AGENDA
PLANNING AND ZONING COMMISSION MEETING
TUESDAY, JUNE 7, 2022 - 6:00 PM
KAUFMAN CITY HALL COUNCIL CHAMBERS
209 SOUTH WASHINGTON STREET,
KAUFMAN, TEXAS 75142

Planning and Zoning Commission Report

SUBJECT: Continue the public hearing and make a recommendation to City Council on a request by Eric Bowman of Cope Equities on approximately 101.016 acres (Property ID 54862 & 54860) to rezone property from Planned Development (PD-3) for Retail, Office, and Multi-Family Residential to **Planned Development (PD-22)** for Commercial/Retail/Flex Office uses on 15.35 acres (Sub-District "A"), Multi-Family Residential uses on 15.5 acres (Sub-District "B"), Single-Family Build-to-Rent uses on 9.20 acres (Sub-District "C"), Townhouse Residential uses on 10.54 acres (Sub-District "D"), and Single-Family Residential uses on 35.88 acres (Sub-District "E"). The proposed development is known as Five Points and is generally located northwest of S. Washington St. at Five Points Dr. in the D. Falcon Survey, Abstract No. 151, City of Kaufman, Kaufman County, TX. (Case No. Z-04-22)

ENGINEERING PD-22 CONCEPT PLAN - OVERALL

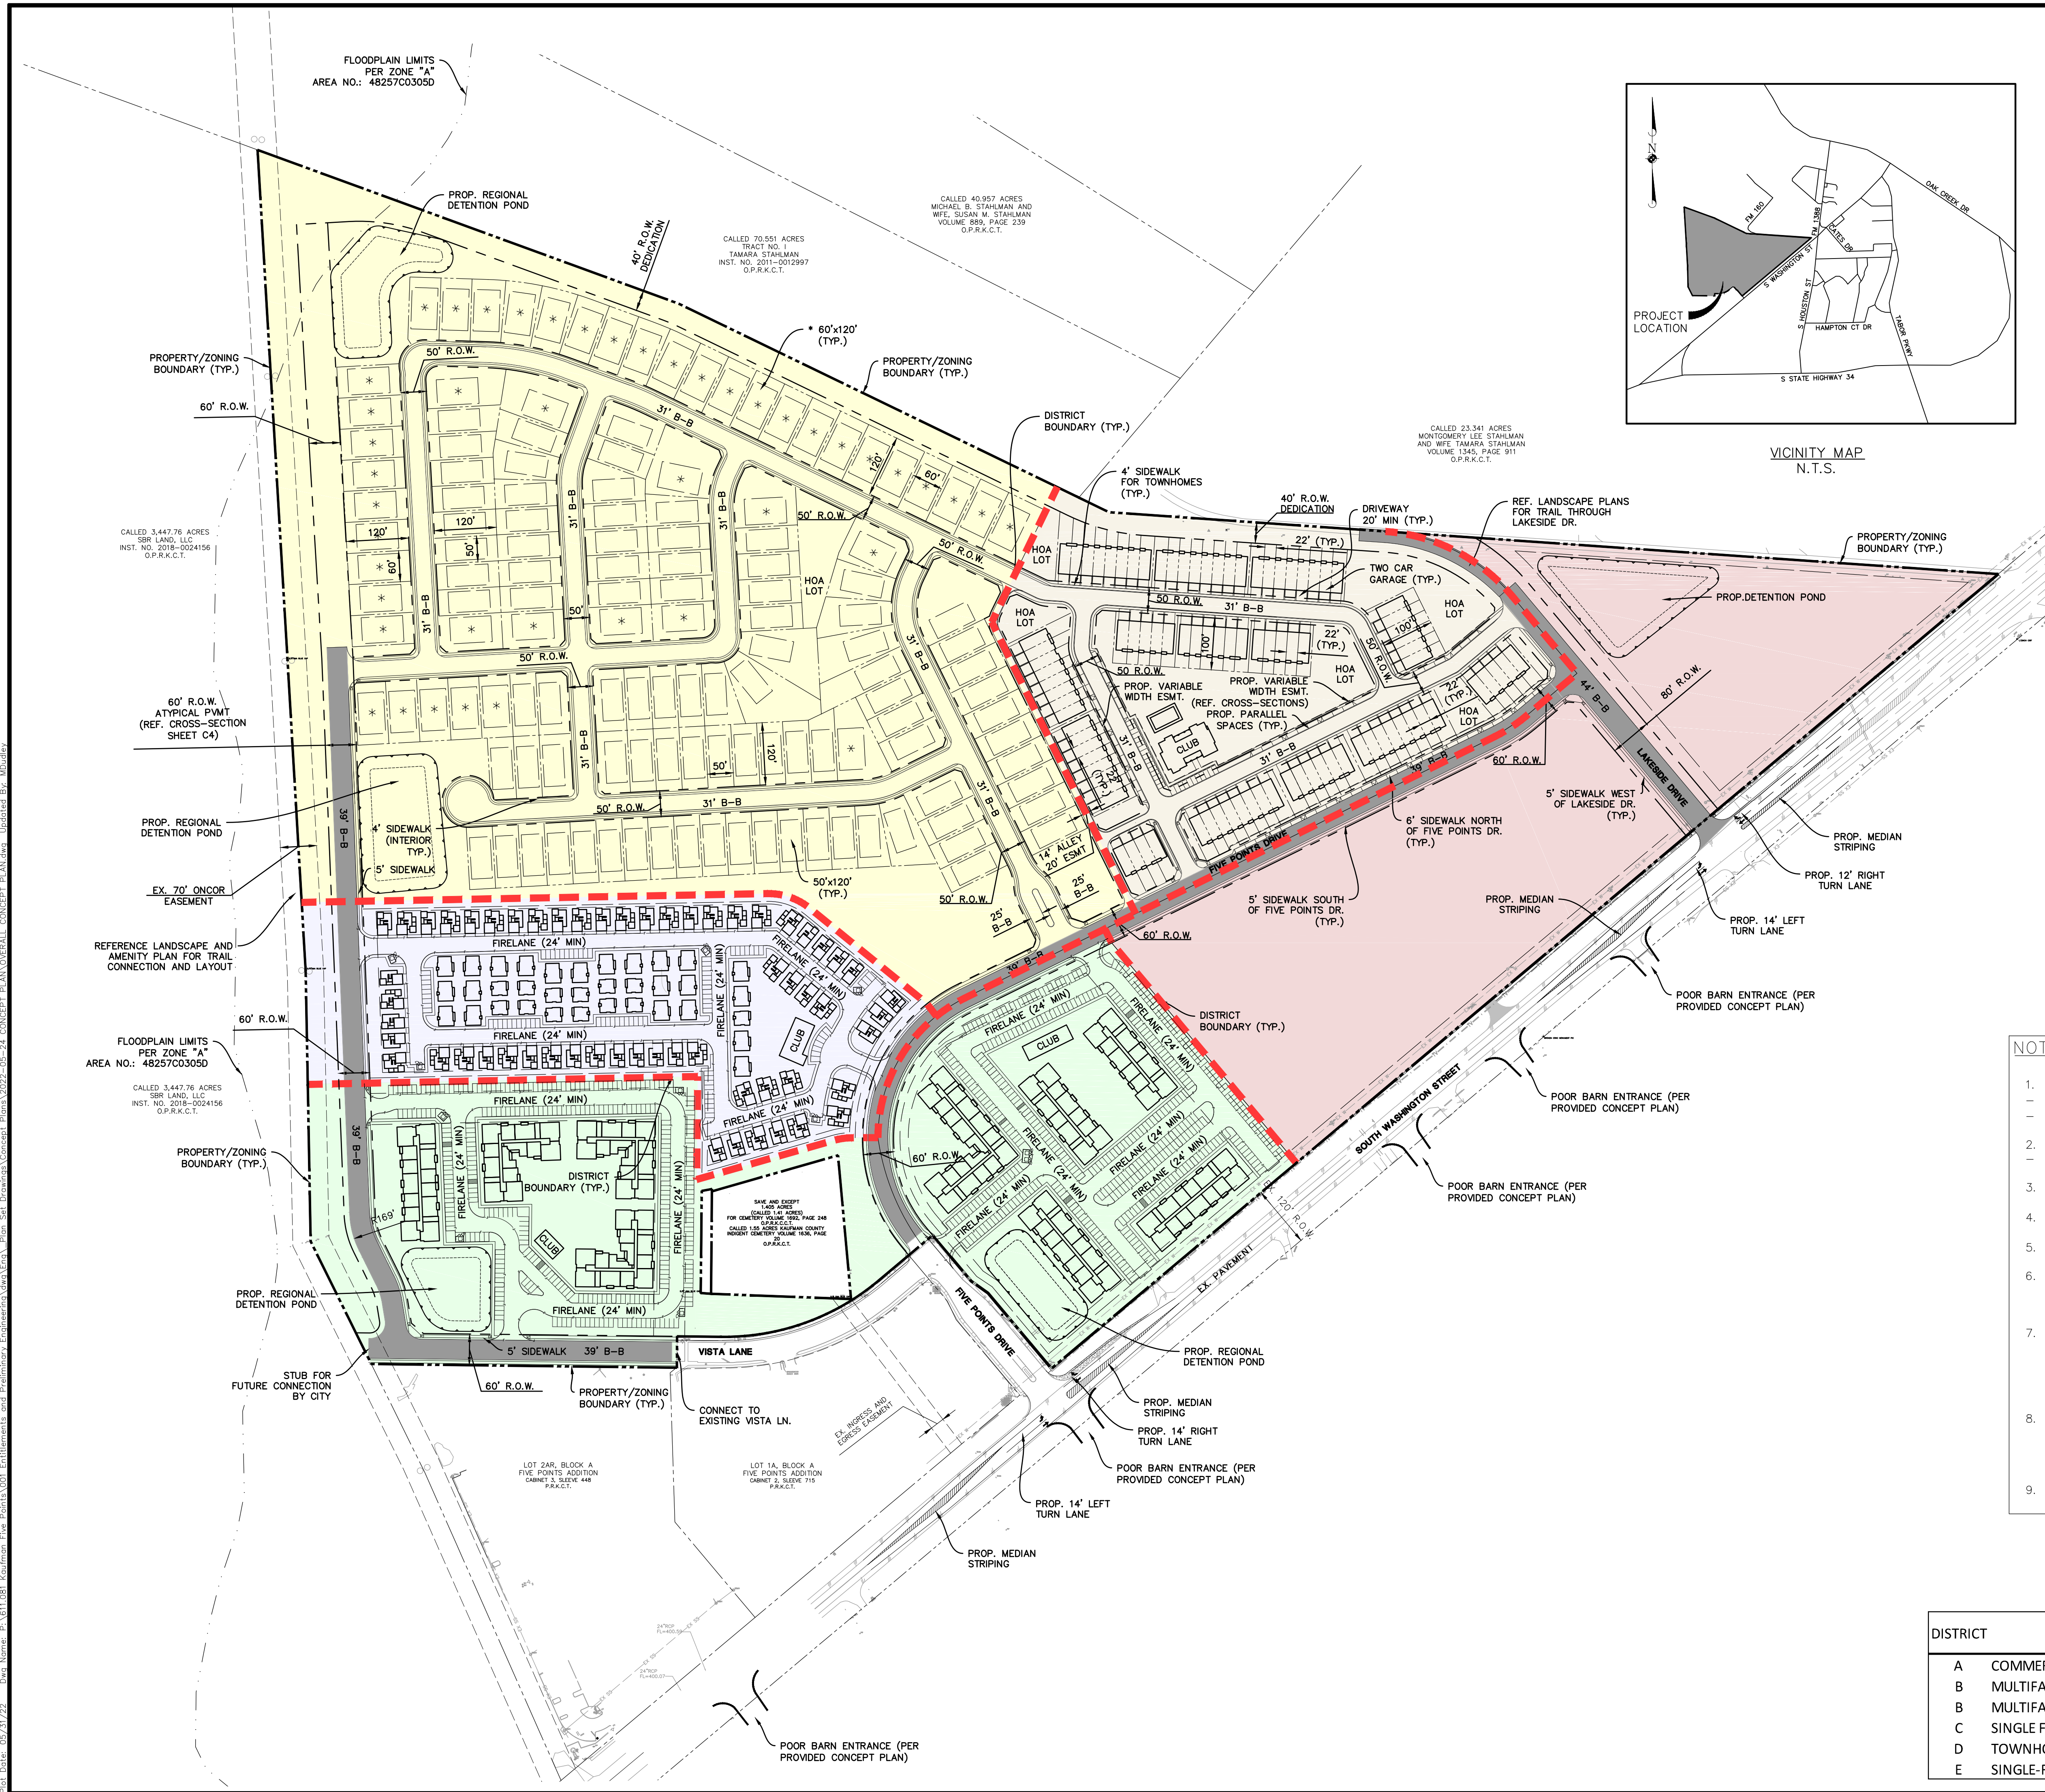
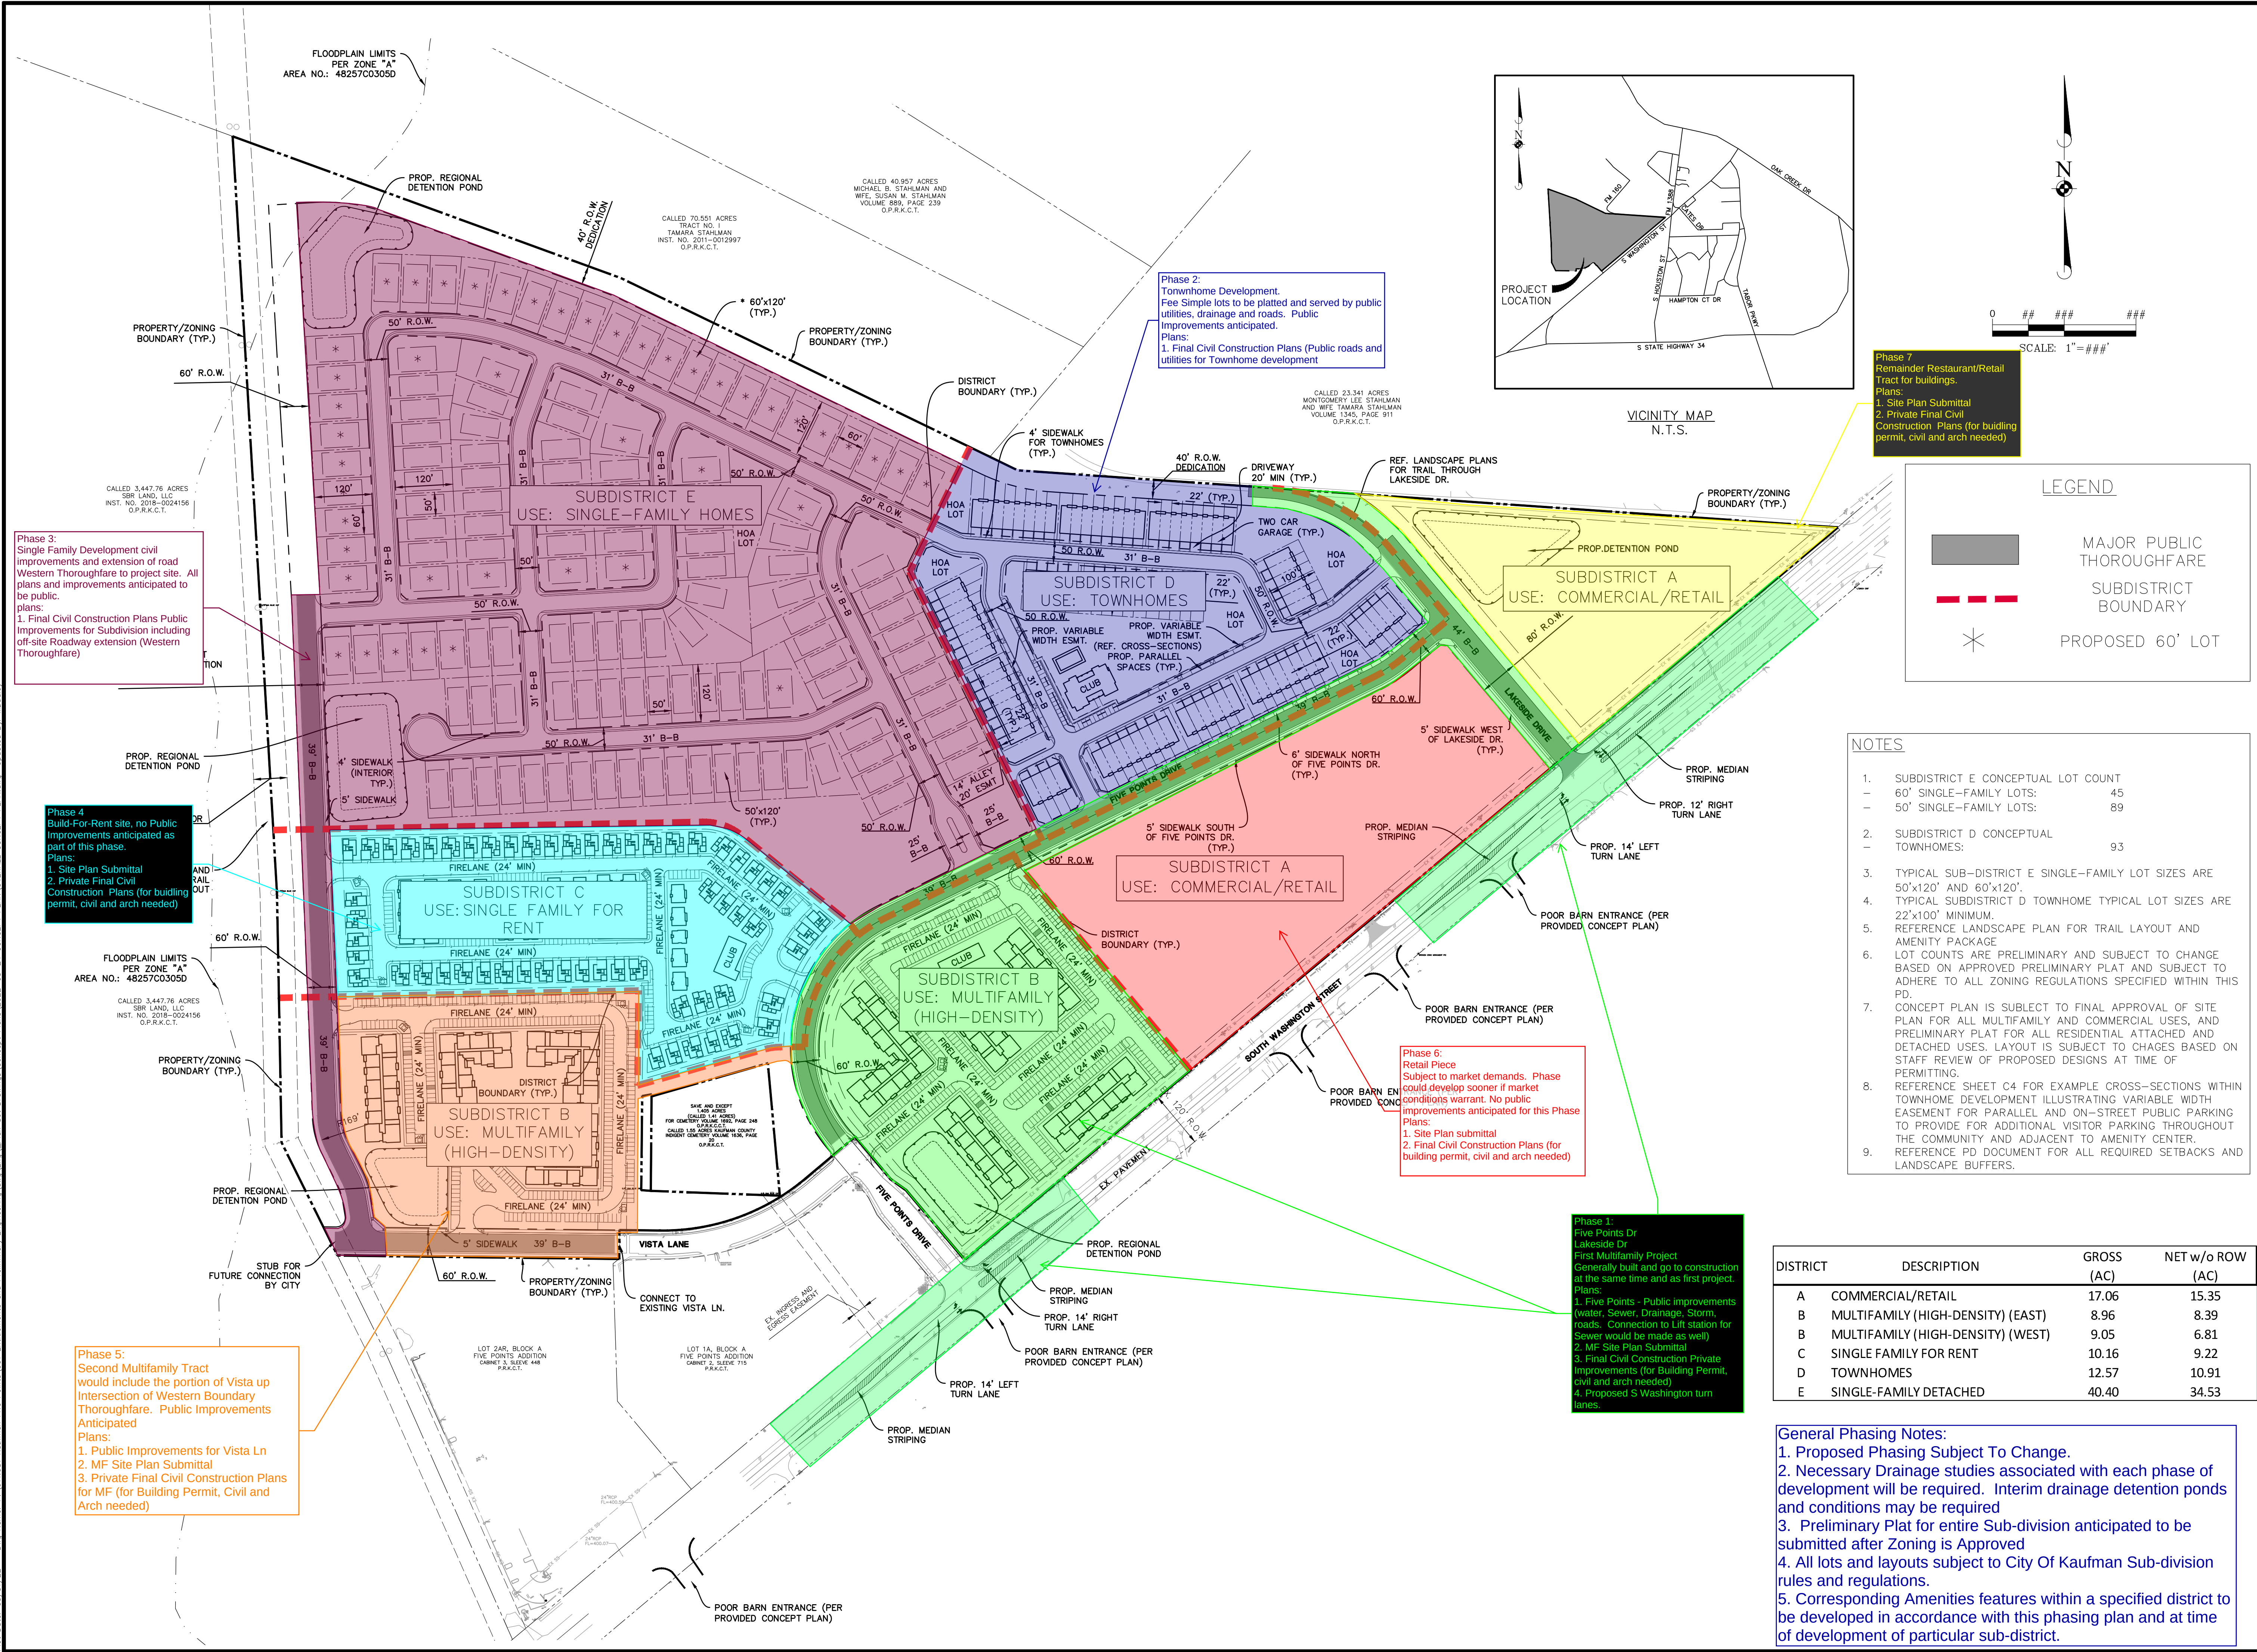
1. The uses permitted in the commercial sub-district "Alcohol beverage sales in conjunction with a restaurant" and "Car washes" should be revised to be subject to SUP approval.

2. Remove the dog park and other park amenities from the right-of-way for the western perimeter thoroughfare.
3. Identify all locations where gated vehicular access is allowed; these locations should be limited to the multi-family and build-to-rent sub-districts.

4. Show and label a screening wall or wood fence with masonry columns along the single-family residential lots that back or side to the western perimeter thoroughfare, as well as along the western and eastern frontages of the build-to-rent sub-district where units back up to or side to public streets.

5. Show and label a steel fence with masonry columns along the frontage of all detention ponds/open space lots adjacent to a public street or right-of-way, around all clubhouse areas, and anywhere else where perimeter fencing is sought.

7. Provide a sidewalk along the north side of Lakeside Drive within the limits of the property.
8. Clarify whether duplexes are permitted or not permitted.
